PCN - 10 042

Product Name:	MILLIPACS		
	MILLIPACS TYPE-A STRAIGHT HEADER		
Product Manager:	JIBU BABU		
Subject:	Product Change Notification		
Distribution:	EU, AP, AM		
Type of Change:	Product Design Change		
Change Description:	<p>The part's moulding is proposed to be changed from a cold runner mould to a standard hot runner mould. Due to difference in the mould construction, resultant changes (as in the picture) are.</p> <ol style="list-style-type: none"> 1. External Walls are Cored out 2. Ejector and Rib at the centre of the part is eliminated. 3. Connector Mating plane is flat. <p>This will not have any impact on the fit and function of the product and product will conform to the IEC 61076-4-101.</p>		
Reason for Change:	To improve the lead time, standardisation of the tooling and process is being undertaken.		
Affected Parts:	See Attached list		
Effective Date of Change:	September	01	2010
Last Time Buy Date:	August	11	2010

Comparison – Existing Vs New (HM2P40P1V1)

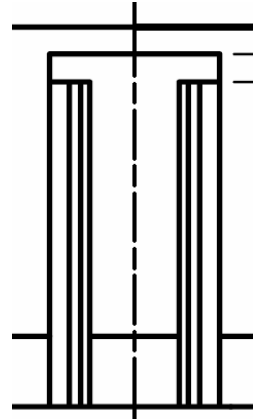
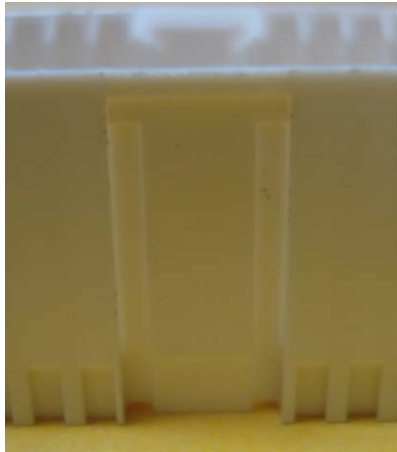
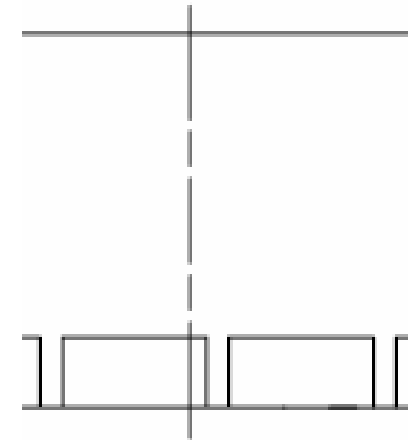
External Wall – Cored Out

External Wall – Flat

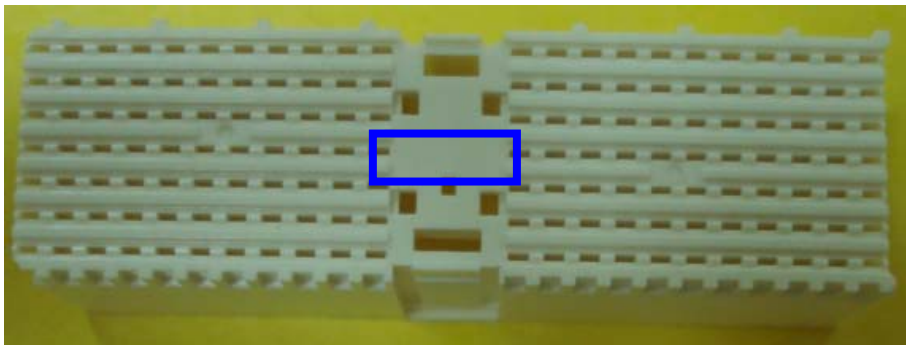
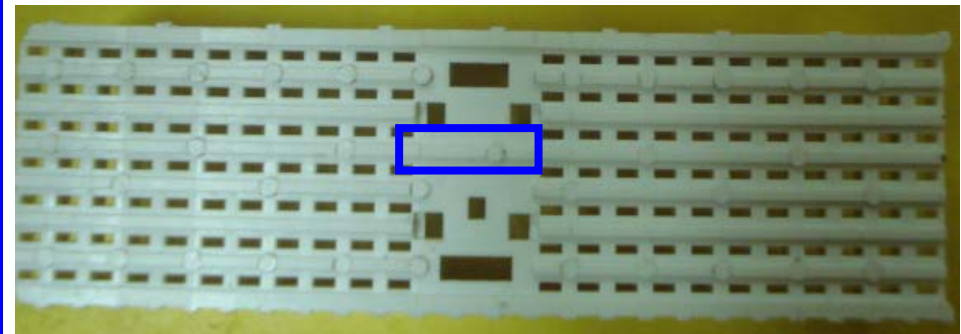
No Ejector and Rib in Center

Ejector & Rib in Center

Comparison – Existing Vs New (HM2P40P1V1)

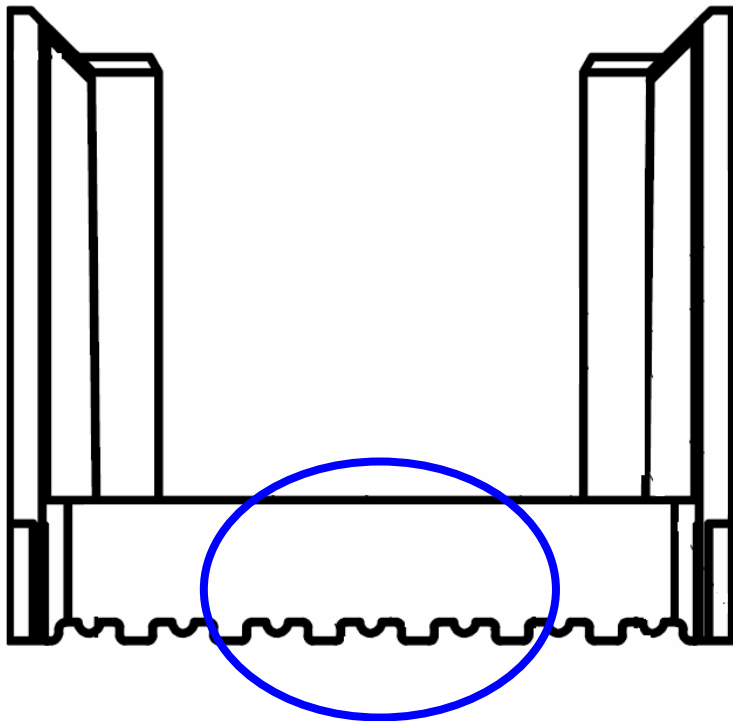
Connector Mating Plane – Flat
Connector Seating Plane – Ribbed

Connector Mating Plane – Ribbed
Connector Seating Plane – Ribbed
